**ENGINEERING REVIEW COMMENTS IN
BLUE BOXES WITH BLUE TEXT**

**Eastonville Road – Londonderry Drive to Rex Road
Segment 1 Improvements
Stationing 14+55.00 – 47+00.00**

Final Drainage Report

EASTONVILLE ROAD - SEGMENT 1
 PROPOSED CONDITIONS DRAINAGE MAP

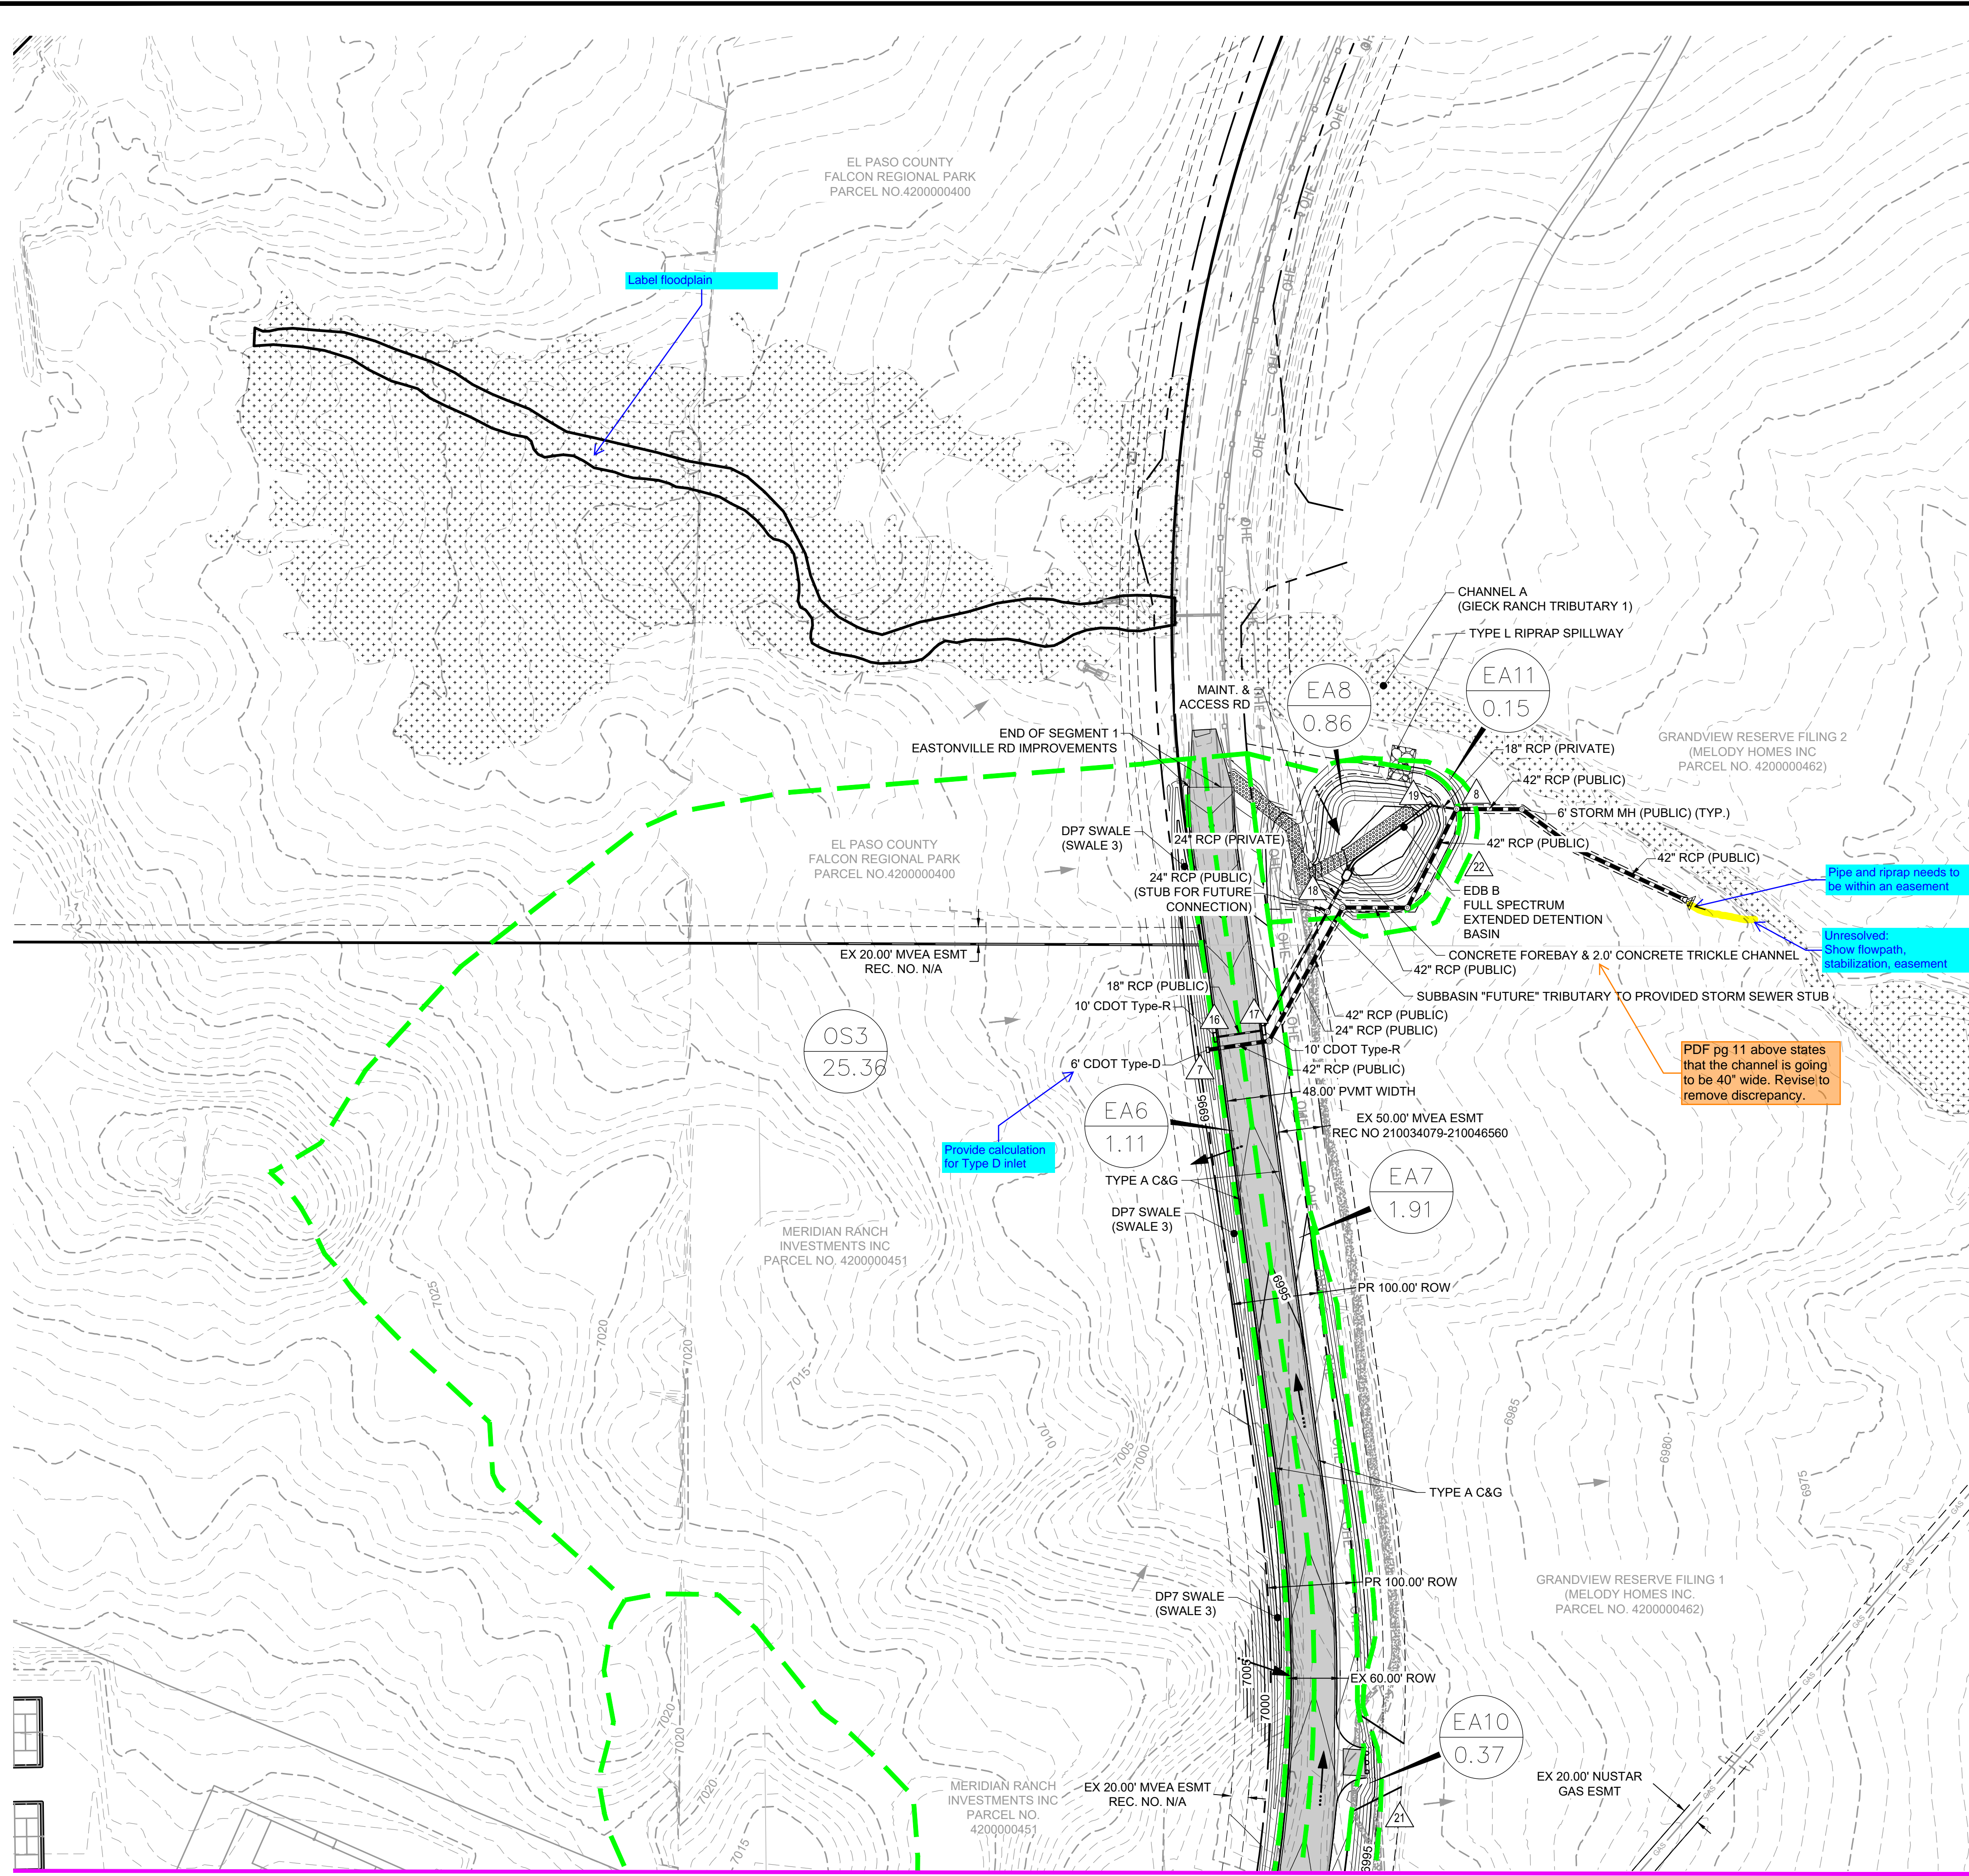
Revise to SFB D for consistency.

Show these DP's on map
